To: Jack Bestall **Subject:** Erie Village PD

ERIE VILLAGE
PD AMENDMENT NO. 6
ERIE COLORADO 6

PLANNED DEVELOPMENT
SUBMITTAL
SHEET TITLE:
COVER SHEET

ERIE VILLAGE PLANNED DEVELOPMENT (PD) DEVELOPMENT PLAN, FILING 5, **6TH AMENDMENT** PDA 07-003

Filing 5 Street Section

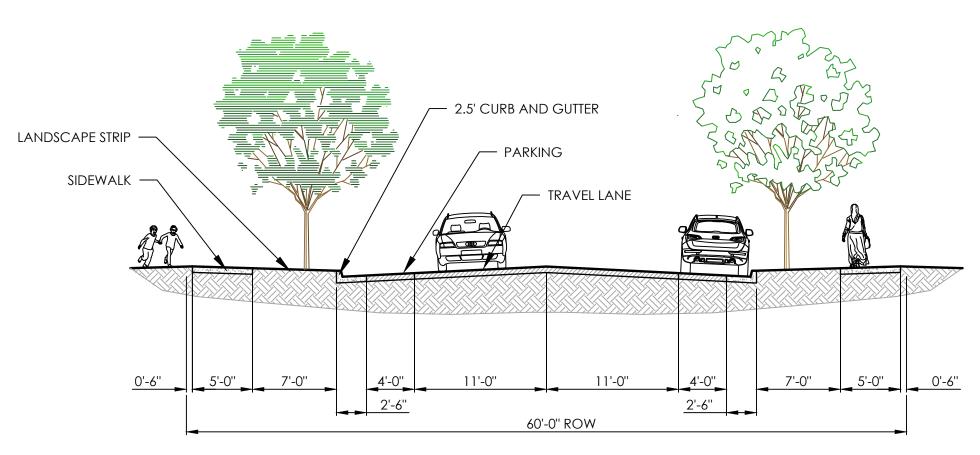
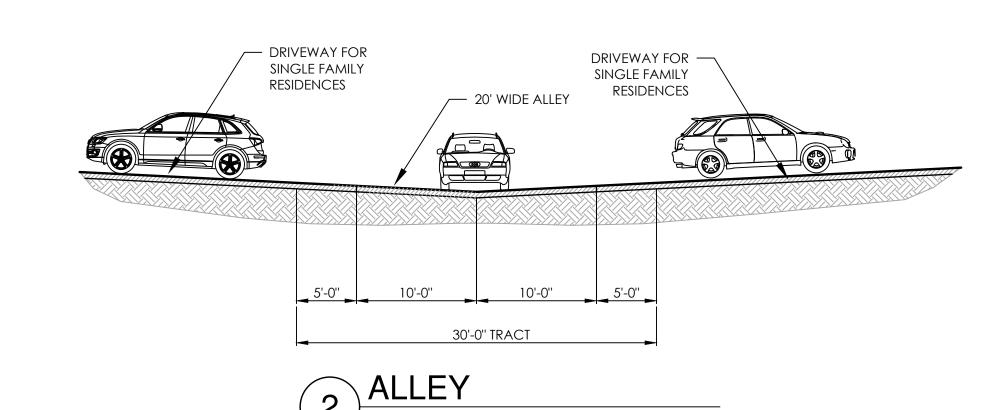
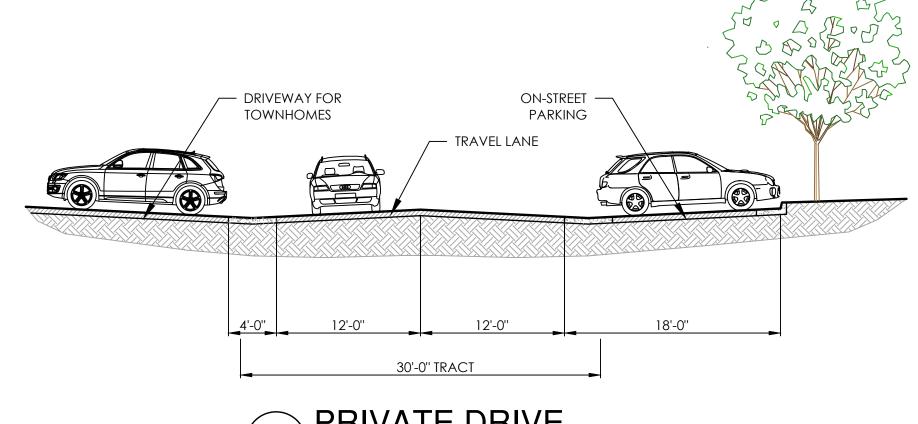
<u>Town Follow-Up:</u> Revision made on PD Development Plan. Conceptual Plot Plan and Site Plan shall be updated as well. Also, revise street sections on page 4 of the Development Plan to read as Private Street.
